Access Compliance Report Public Rights-of-Way (Pedestrian Signals)

Main Street: **EDINGER_AVE** Cross Street: **HARBOR_BLVD** Location: **NW**

ADA ID: **SGRK220222152844** Signal Type: **One Push Button-Non APS** Overall Compliance: **No** Severity Scores: **BTN 1: 10** **BTN 2: N/A** **No BTN: N/A**

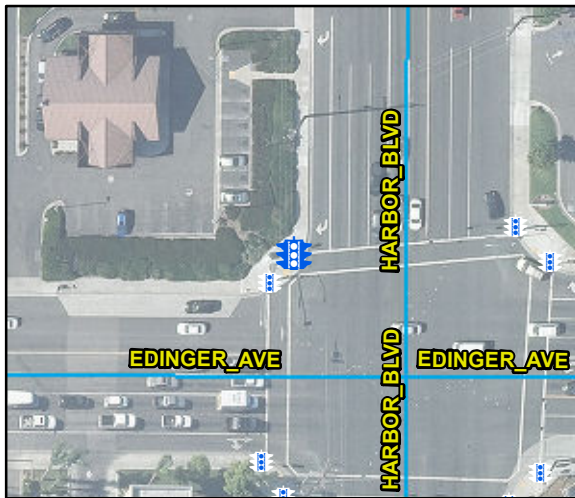
N/A Is Button 1 APS or Non-APS?	NonAPS	N/A Is Button 2 APS or Non-APS?	N/A
N/A B 1 VibroTact Arrow?	N/A	N/A B 2 VibroTact Arrow?	N/A
N/A B 1 VibroTact Parallel to Xing?	N/A	N/A B 2 VibroTact Parallel to Xing?	N/A
N/A B 1 VibroTact Contrast	N/A	N/A B 2 VibroTact Contrast	N/A
No B 1 Pilot Light?	No	N/A B 2 Pilot Light?	N/A
N/A B 1 Pilot Light Illumination?	N/A	N/A B 2 Pilot Light Illumination?	N/A
N/A B 1 Walk Indicator Type	N/A	N/A B 2 Walk Indicator Type	N/A
N/A B 1 Walk Indicator Audible?	N/A	N/A B 2 Walk Indicator Audible?	N/A
N/A B 1 Locator Tone?	N/A	N/A B 2 Locator Tone?	N/A
N/A B 1 Tone Audible Range?	N/A	N/A B 2 Tone Audible Range?	N/A
B 1 Addl APS Features?	No	B 2 Addl APS Features?	N/A
B 1 Addl APS Features Notes	N/A	B 2 Addl APS Features Notes	N/A

Possible Solutions: Replace Signal Push Button With APS Button.
